167 DANFORTH STREET

Re: 167-169 Danforth Street

Permit to construct fire escape on back of house, 4 x 8 as per plans 1 sheet of plans

TOP VIEW (LADDER)

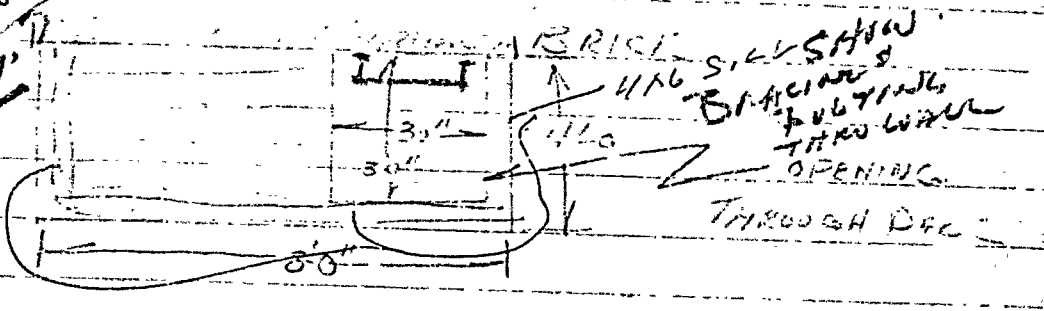
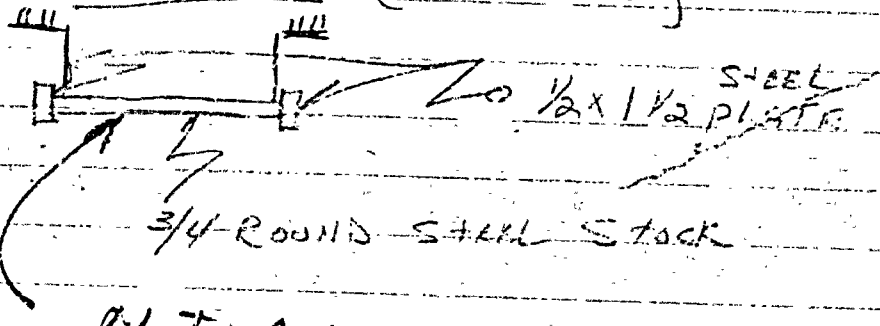
10/15/76 Fire escape added  
 under 11 Code (Sec 5-5.1) Check with  
 Fire Marshall 10/16 Fire Marshall says the  
 same and allowable. Not allowed under 11.00  
 if it is to be as stated on the plan  
 with the application (Sec 6.2.1) or (Sec 6.1.1)  
 11-1-76 Mr. Brown okayed this - see Attached memo -  
 Doesn't appear any work has been started -   
 11-22-76 Same -   
 12-8-76 Same - Mr. B  
 3-17-77 Same -   
 11-16-77 Not installed -  
 permit expired -

NOT ALLOWED  
 MUST BE STAIRS TO  
 MAX 10' ABOVE GRAB - THEN  
 METAL DROP LADDER ON  
 COUNTER BALANCE STAIR.

167-169 DANFORTH ST  
PORTLAND, MAINE

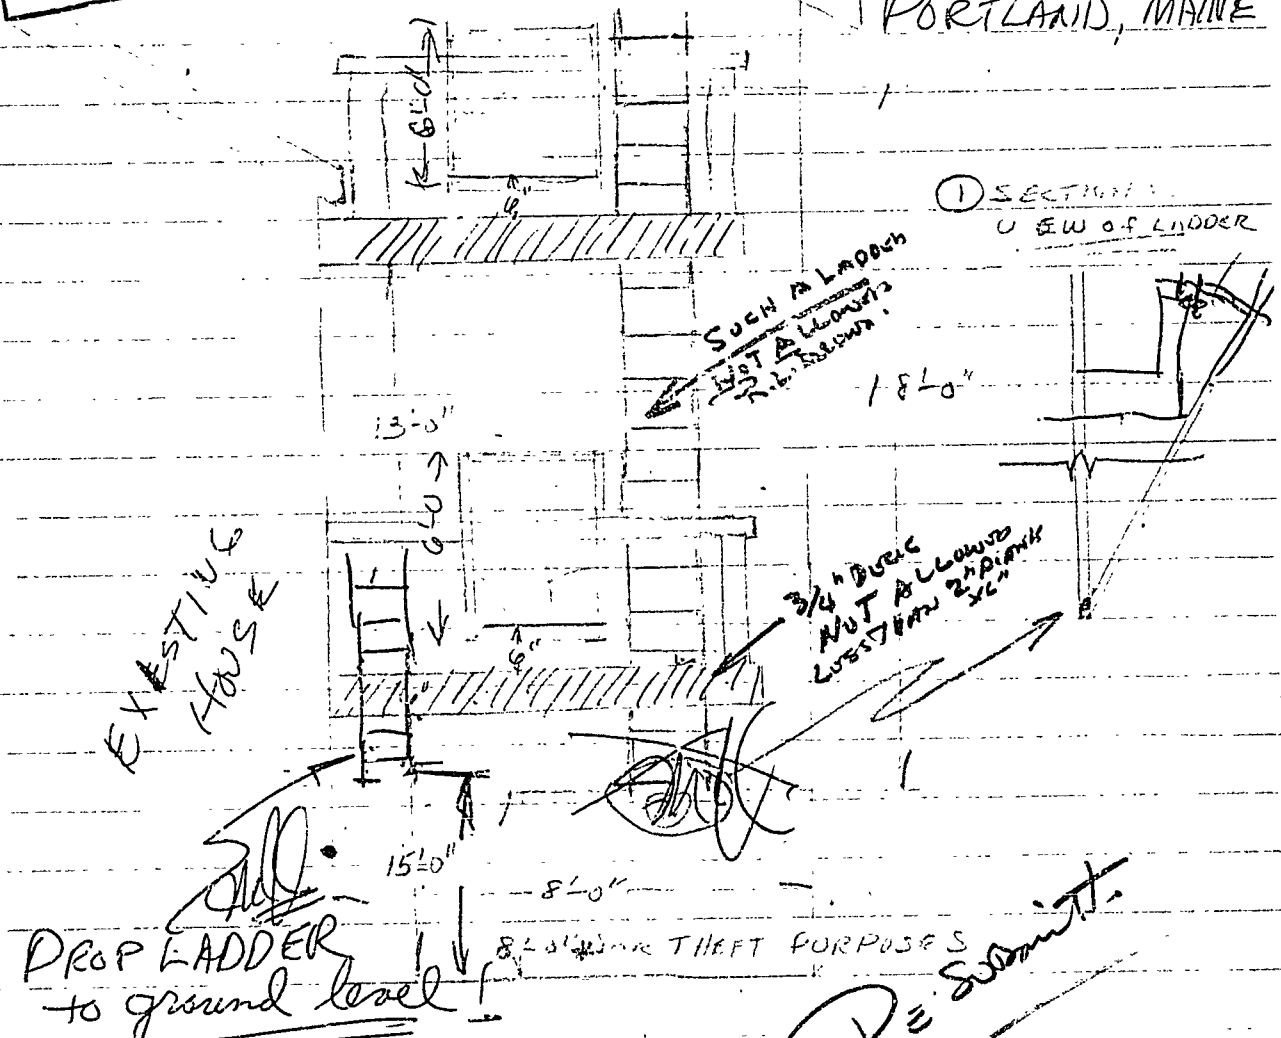
Re Submit

NO  
HOW BRACES  
THRU WALL  
BOLTS ETC.

DANTONIA S. 111

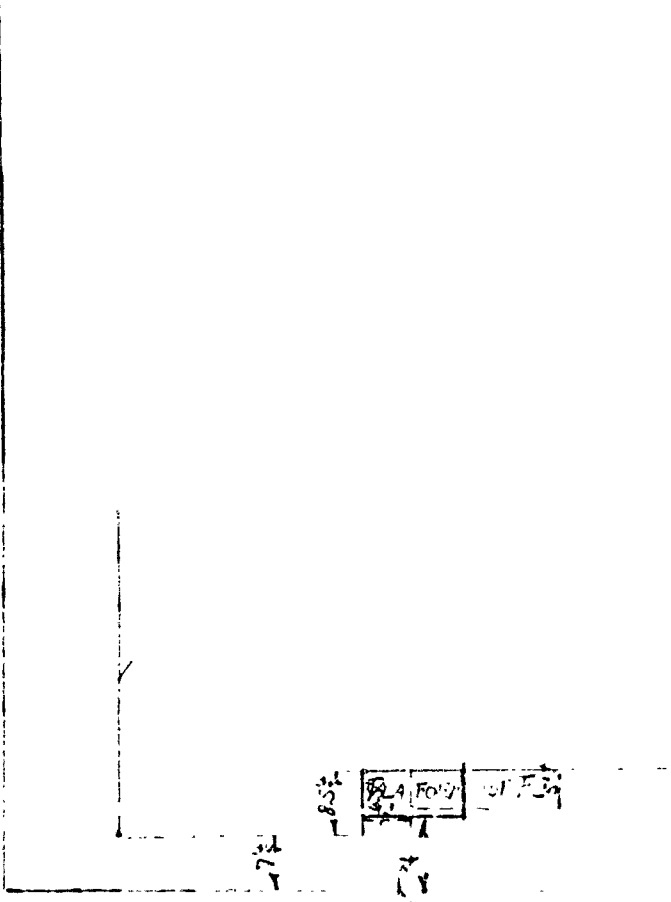
Building permit for erection of an outside wooden stairway from third floor to existing porch at first floor level on Winter Street side of building at the above location is issued herewith based on revised plan and specifications filed with application for permit, but subject to the following conditions:-

WILL THE ARRANGEMENT SHOWN ON THE ATTACHED PLAN SATISFY YOUR ORDERS OF 9/21/49, 3/31/47, and 2/15/50 AS PROVIDING AN ADEQUATE EMERGENCY MEANS OF EGRESS FROM THIS BUILDING?

- width of treads of stairway is to be not less than nine inches and height of risers not more than  $8\frac{1}{2}$  inches, these measurements to be taken on the stair points.
- the fixed ladder extending from lower landing to porch floor is to be at least 18 inches wide, is to set off from wall of building far enough to provide ample toe space, and is to be adequately fastened to the wall.
- it should be noted that the lower platform is to be not more than 10 feet above the surface of the ground.
